Product Change Notice (PCN)

PCN Number: PCN-0451201R-02

Product(s) Affected: *PJ-056*

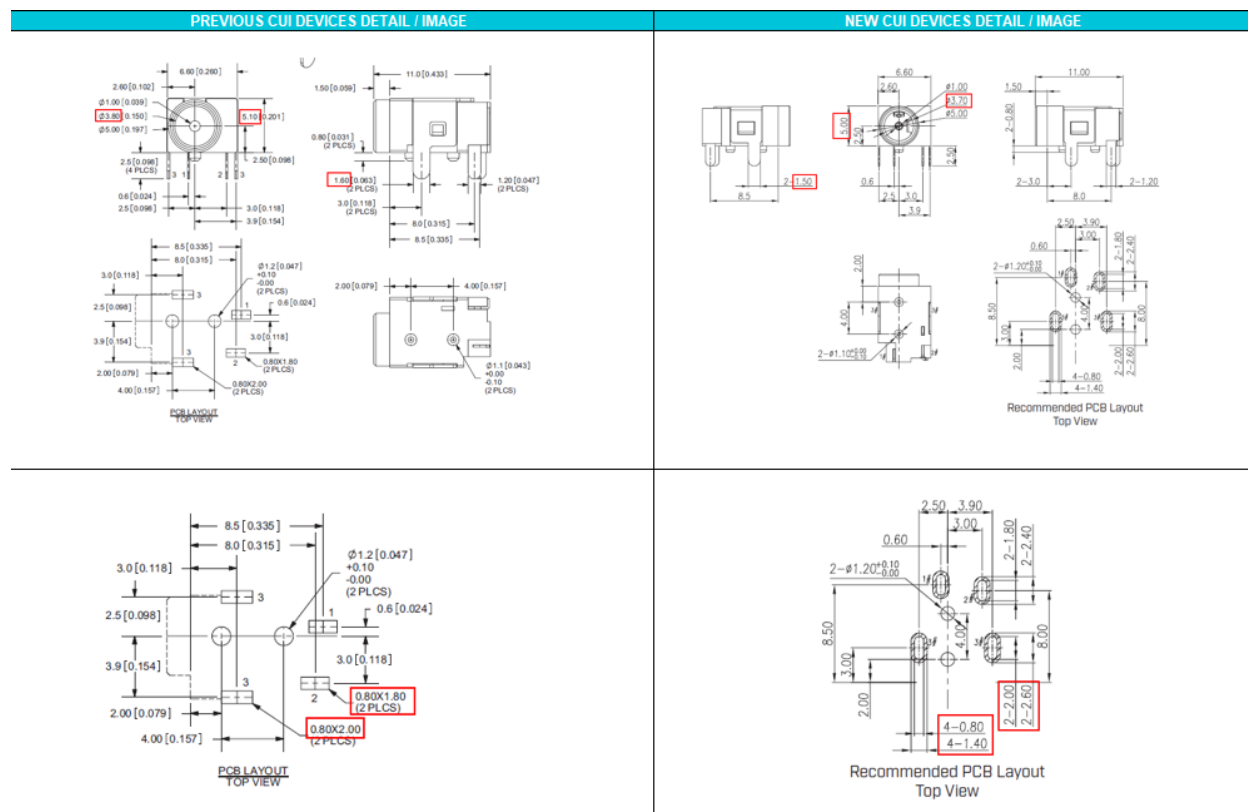
Description of Change: *Minor Housing and Material Difference. See image Below*

PREVIOUS CUI DEVICES DETAIL / IMAGE			NEW CUI DEVICES DETAIL / IMAGE		
	MATERIAL	PLATING			
center pin	brass	tin			
terminal 1	brass	tin	DESCRIPTION	MATERIAL	PLATING/COLOR
terminal 2	copper alloy	tin	terminal 1	brass	tin
terminal 3	copper alloy	tin	terminal 2	copper alloy	tin
plastic	PA66		terminal 3	copper alloy	tin
			housing	PBT (UL94V-0)	black
